Appendix F
Responses to Comments

RESPONSES TO COMMENTS

On July 9, 2021, the California State University Monterey Bay (CSUMB) campus circulated for public review a Draft Initial Study and Proposed Mitigated Negative Declaration (Draft IS/MND) for the Freeman Stadium Facilities Renovation Project (proposed project) at CSUMB. As required by Section 15073 of the California Environmental Quality Act (CEQA) Guidelines, the Draft IS/MND was circulated for 30 days. The comment period closed on August 9, 2021. CSUMB received six (6) comment letters on the Draft IS/MND during the public review period. All comments received on the Draft IS/MND are addressed in this appendix.

COMMENTS FOR THE MITIGATED NEGATIVE DECLARATION (MND) – FREEMAN STADIUM FACILITIES RENOVATION PROJECT, SEASIDE, CA

Figure
1

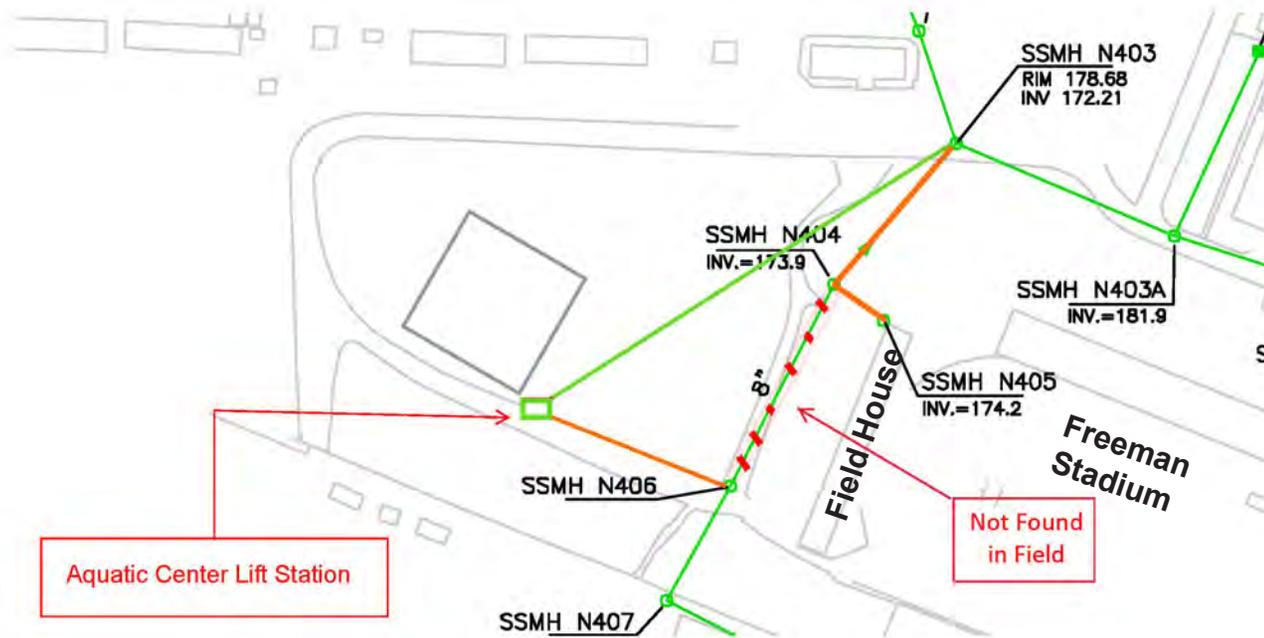
The comment states that the Draft IS/MND includes assessments only of water and wastewater [utility] capacity and does not address facility condition and/or re-location. The comment further states that "[t]he existing water and wastewater facilities will be impacted by the proposed project" and that additional assessments and associated mitigation measures are needed in the Draft IS/MND.

With respect to the capacity of the sanitary sewer infrastructure serving the project site, an Addendum to the 2019 Sanitary Sewer Capacity Analysis prepared in May 2020 reviewed future growth on the CSUMB campus as proposed in the Draft 2017 Campus Master Plan, which included approximately 50,000 net new square feet of athletic and recreational facilities. Based on review of all pipe lengths, sizes, and inverts used for the analysis obtained from MCWD, system maps, and campus as-built plans. The 2020 Addendum concluded that the entirety of the campus sanitary sewer system had ample capacity to serve the campus’s future growth. The 2020 Addendum specifically concluded that the capacity deficiency cited in the 2007 Master Plan EIR and in the 2019 Sanitary Sewer Analysis report in Collector H between Manholes H316 and H317 was mistakenly identified based on a drawing error in a MCWD map and that no deficiency exists in that line. (Whitson Engineers, Addendum – Sanitary Sewer Capacity Analysis, California State University, Monterey Bay, May 2020). The modest increase in wastewater generated by the Field House as the result of the Freeman Stadium Facilities Renovation project is well below that assumed in the 2020 Addendum for the future athletic and recreational facilities square footage increase, and, therefore, would be accommodated by the existing sanitary sewer system serving the project site.

Collector N is the portion of the existing sanitary sewer system that serves the project site. In addition to commissioning the 2019 Sanitary Sewer Capacity Analysis, CSUMB investigated the physical condition of Collector N in June 2021 as part of preparation of the Draft IS/MND and plans for the Freeman Stadium Facilities Renovation Project. In 2007, in consultation with the MCWD, the campus replaced the portion of on-campus Collector N sanitary sewer infrastructure between manholes N405, where the project would connect to the system, and manhole N403, as shown in **Figure 1** of this Appendix. This line was visually inspected by camera and based on this inspection was determined to be in excellent condition (communication with Mike Lerch, Director of Energy and Utilities, Energy Management Services, CSUMB, August 2021; Inspection Report, Sections 1 through 6, prepared by Greenline, June 16, 2021; and Monterey Bay FC Facilities Renovation Civil Existing Condition Map, verified by Greenline, May 2021) (**Attachment 1** to this Appendix). Accordingly, no replacement or relocation of the existing sanitary sewer line serving the project site is warranted.
